ADDENDUM NO. <u> 1 </u>	DATED <u> 10/15/2019 </u>	ADDENDUM NO. _____	DATED _____
ADDENDUM NO. _____	DATED _____	ADDENDUM NO. _____	DATED _____
ADDENDUM NO. _____	DATED _____	ADDENDUM NO. _____	DATED _____

SUPPLEMENT TO SPECIAL PROVISION NO. 907-618-4

DATE: 10/15/2019

PROJECT: STP-0067-01(010) / 107686301 – Hancock County

ADDITIONAL TRAFFIC CONTROL SIGNS REQUIRED:

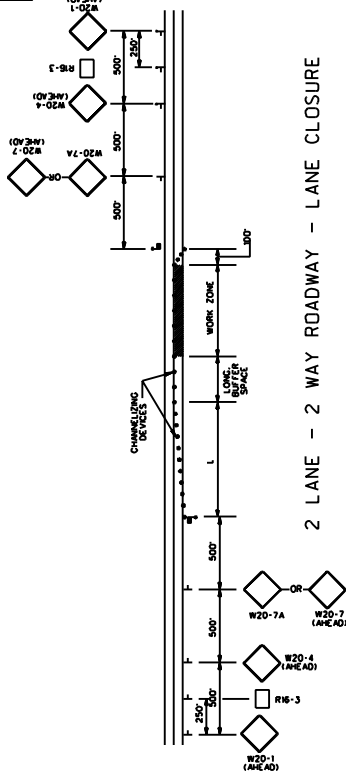
After the first paragraph of Subsection 907-618.01.2 on page 1, add the following.

Additional [traffic control devices](#) will be required as follows.

- 22 - W20-1 "AHEAD" signs required. One (1) W20-1 "AHEAD" sign is required at each local road or street entering the project.
- 3 - W20-2A "END ROAD WORK" signs required.
- 17 - R4-1 "DO NOT PASS" signs required.
- 18 - R4-2 "PASS WITH CARE" signs required.
- 2 - R16-3 "SPEEDING FINES DOUBLED" signs required.

All [construction signs and barricades shown on this page shall be](#) included in the bid [price](#) for Pay Item 618-A, Maintenance of Traffic. Fluorescent orange sheeting shall be used on all construction and traffic control signs except for R16-3, R4-1 and R4-2 signs which shall be black legend and border on white background.

LOCATION OF R16-3 SIGNS

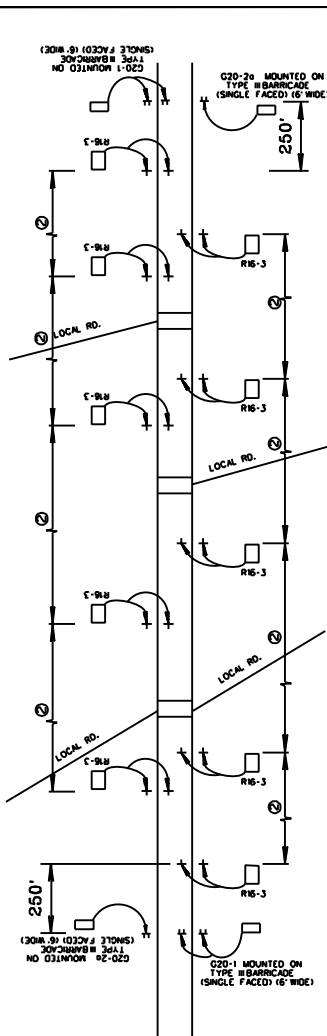
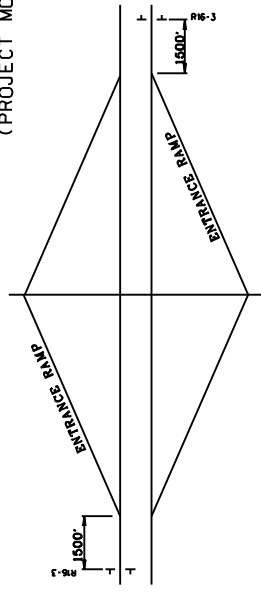
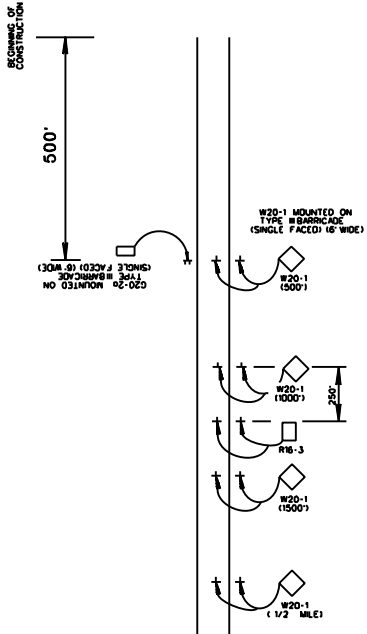
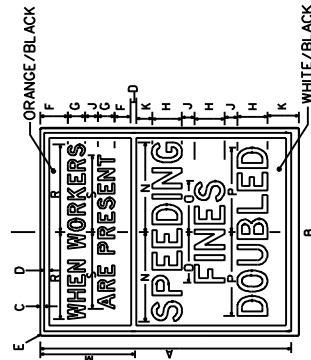
R16-3 signs shall be spaced in accordance with sheet titled "Location of R16-3 Signs".

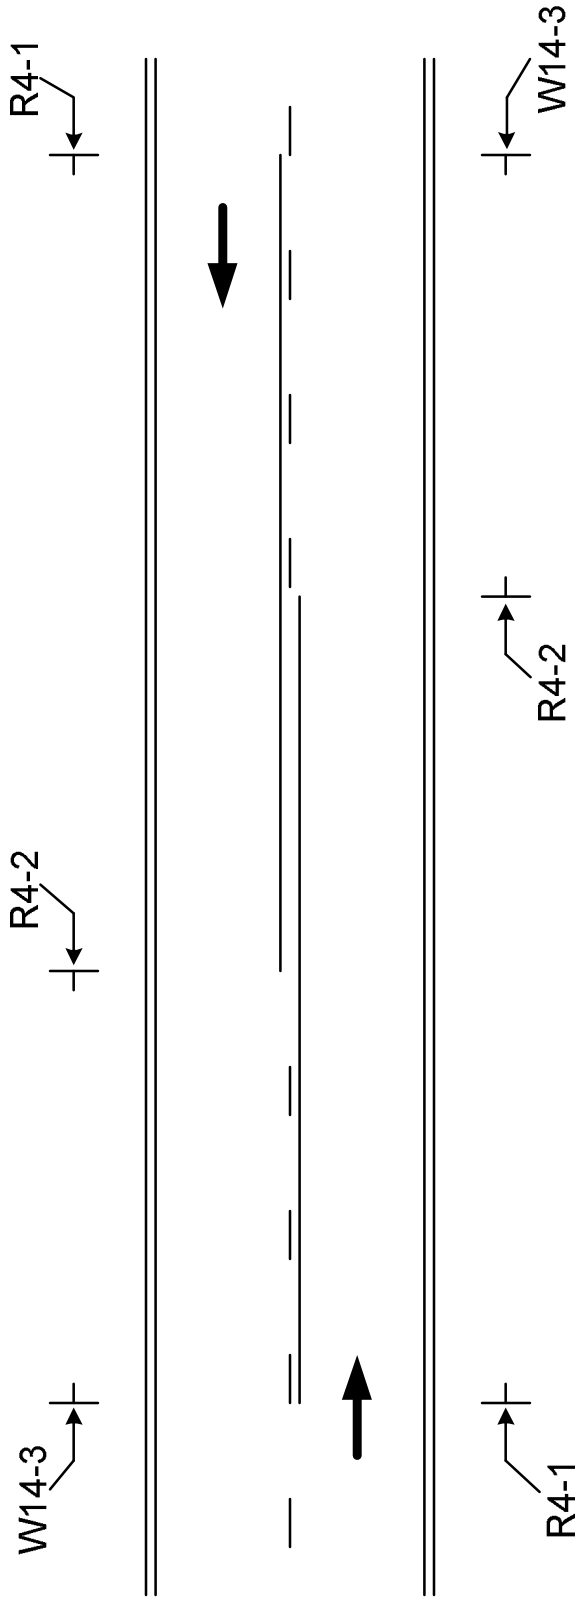
R4-1 "DO NOT PASS", R4-2 "PASS WITH CARE", and W14-3 "NO PASSING ZONE" signs are required in accordance with Subsection 618.03.3, this drawing, and as specified in the Manual on Uniform Traffic Control Devices.

The W14-3, No Passing Zone sign, shall be placed on the left side of the road at the beginning of each no passing zone.

The R4-1, Do Not Pass signs, shall be placed on the right side of the road at the beginning of the no passing zone. Additional R4-1 signs shall be placed right and left in increments of 750 to 1000 feet throughout the length of the no passing zone.

The R4-2, Pass With Care sign, shall be placed on the right side of the road at the end of the no passing zone.

The R4-1, R4-2 and W14-3 signs are to be used when standard pavement markings are not in place. The signs may also be used to emphasize pavement markings.
